## Product / Process Change Notification (PCN)

**PCN #:** PCN\_IndFI\_20201218

**Affected Series:** WE-FI; 74470xx

**PCN Date:** September 11, 2020

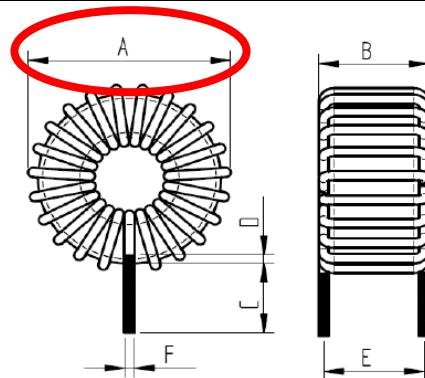
Because of a database mismatch, Würth Elektronik will correct the mechanical dimensions of the parts specified in "Detail of change".

Part Number	Length before Change [A] max.	Length after Change [A] max.
7447011	17.5 mm	18.5 mm
7447021	15.5 mm	16.5 mm
7447022	15 mm	15.5 mm
7447024	15 mm	15.6 mm
7447030	13 mm	13.5 mm
7447032	13 mm	13.5 mm
7447034	13 mm	13.5 mm
7447035	13 mm	13.5 mm

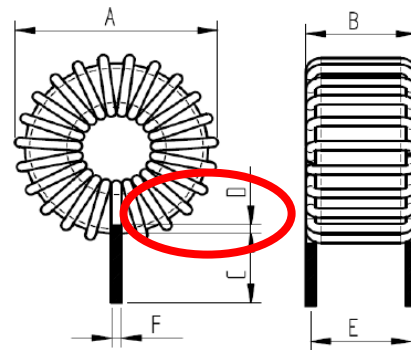
Part Number	Tin Length before Change [D]	Tin Length after Change [D] min.
7447015	1.5 mm	1 mm
7447017	1.5 mm	1 mm
7447019	2 mm	1 mm
7447021	1.5 mm	1 mm
7447022	1.5 mm	1 mm
7447025	1.5 mm	1 mm
7447026	0 mm	1 mm
7447031	1.5 mm	1 mm
7447032	1.5 mm	1 mm
7447035	1.5 mm	1 mm
7447037	1.5 mm	1 mm
7447040	1.5 mm	1 mm
7447041	1.5 mm	1 mm
7447042	1.5 mm	1 mm
7447043	1.5 mm	1 mm
7447051	1.5 mm	1 mm
7447052	1.5 mm	1 mm

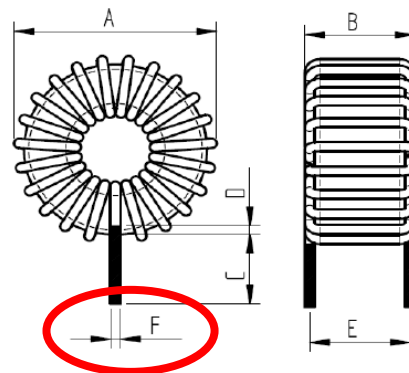
Part Number	Pin Diameter before Change [F]	Pin Diameter after Change [F]
7447013	0.798 mm	0.8 mm
7447014	0.798 mm	0.6 mm
7447015	0.802 mm	0.8 mm
7447020	0.498 mm	0.5 mm
7447021	0.598 mm	0.6 mm
7447023	0.802 mm	0.8 mm
7447024	0.598 mm	0.6 mm
7447025	0.802 mm	0.8 mm
7447026	0.998 mm	1 mm
7447027	0.998 mm	1 mm
7447031	0.498 mm	0.5 mm
7447033	0.598 mm	0.6 mm
7447035	0.598 mm	0.6 mm
7447040	0.302 mm	0.3 mm
7447041	0.398 mm	0.4 mm
7447042	0.302 mm	0.3 mm
7447043	0.498 mm	0.5 mm
7447044	0.598 mm	0.6 mm
7447051	0.29 mm	0.3 mm
7447052	0.498 mm	0.5 mm
7447053	0.498 mm	0.5 mm
7447054	0.602 mm	0.6 mm
7447065	1 mm	0.8 mm

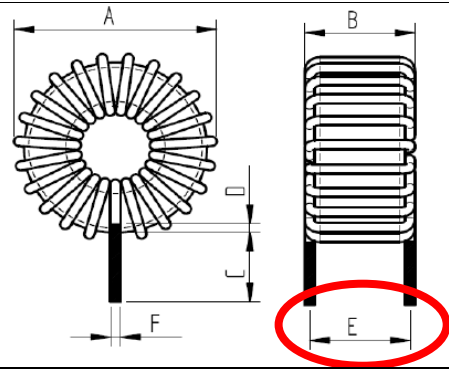
Part Number	Pin Distance before Change [E]	Pin Distance after Change [E]
7447022	6.5 ± 2 mm	6 ± 2 mm
